Proposal for the 10 series of amendments to UN Regulation No. 17 (Strength of seats, their anchorages and head restraints)

Submitted by the Working Party on Passive Safety *

The text reproduced below was adopted by the Working Party on Passive Safety (GRSP) at its sixty-fifth session (ECE/TRANS/WP.29/GRSP/67, para. 12). It is based on ECE/TRANS/WP.29/GRSP/2020/8 as amended by Annex IV to the report. It is submitted to the World Forum for Harmonization of Vehicle Regulations (WP.29) and to the Administrative Committee (AC.1) for consideration at their November 2020 sessions.

Figure 1
Non-Use Warning Labels

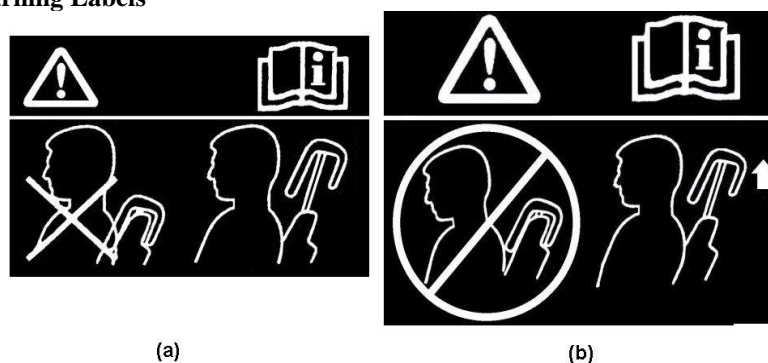
- 5.8.4.5. The presence of a non-use position of a head restraint shall be marked with a label, in the form of a pictogram which may include explanatory text. The label shall either provide an indication when the head restraint is in a non-use position or provide information to enable an occupant to determine whether the head restraint is in a non-use position. The label shall be durably affixed and located such that it is clearly visible by an occupant when entering the vehicle to the designated seating position. Examples of possible designs of pictograms are shown in Figure 1.

Model B

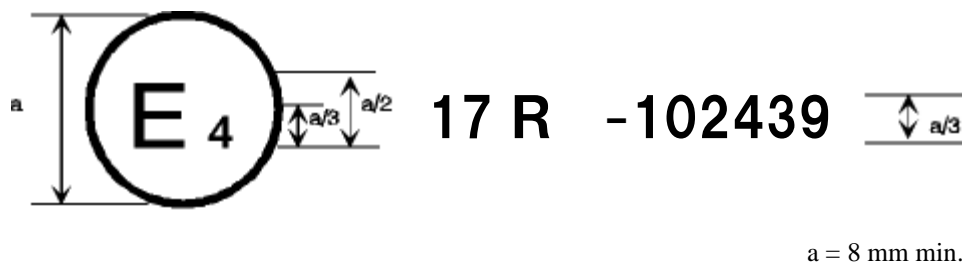
The above approval mark when affixed to a vehicle shows that the vehicle type has seats not fitted or capable of being fitted with head restraints, and has, with regard to the strength of the seats and their anchorages, been approved in the Netherlands (E 4) pursuant to Regulation No. 17 under the approval number 102439. The first two digits of the approval number indicate that the Regulation already contained the 10 series of amendments at the time of approval.

Model C

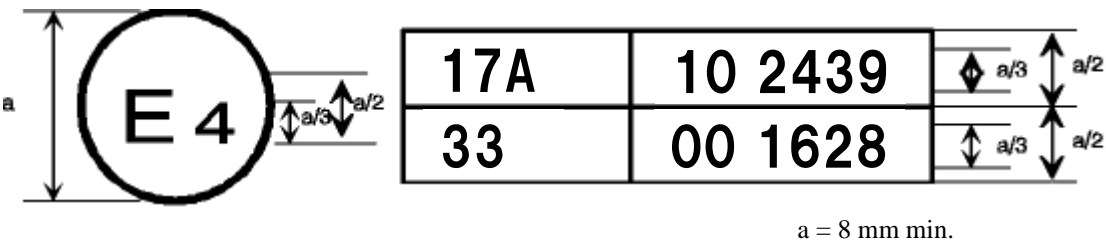
The above approval mark when affixed to a vehicle shows that the vehicle type has at least one seat fitted or capable of being fitted with a head restraint, and was approved in the Netherlands (E 4) pursuant to UN Regulations Nos. 17 and 33.¹

Model D

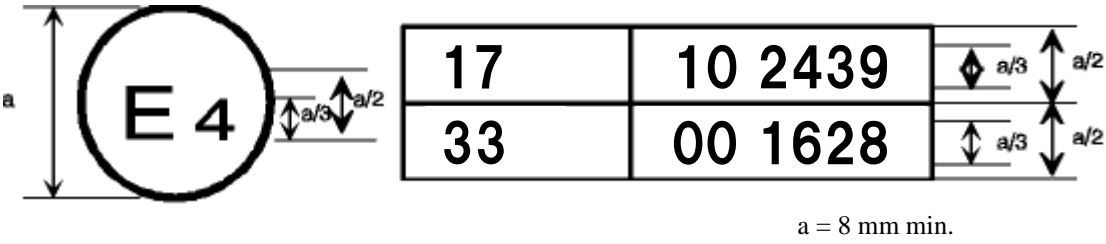
The above approval mark when affixed to a vehicle shows that the vehicle type has seats not fitted or capable of being fitted with head restraints, and was approved in the Netherlands (E 4) pursuant to UN Regulations Nos. 17 and 33.¹ The approval numbers indicate that, on the dates when approval was granted, UN Regulation No. 17 included the 10 series of amendments but UN Regulation No. 33 was still in its original form."

Figure 10-6

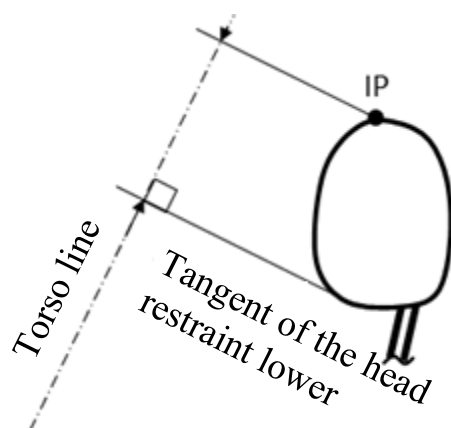
5.6.7. The height of the front contact surface of the head restraints, measured as described in Figure 10-6 of Annex 10 shall not be less than 100mm except for integrated head-restraints.
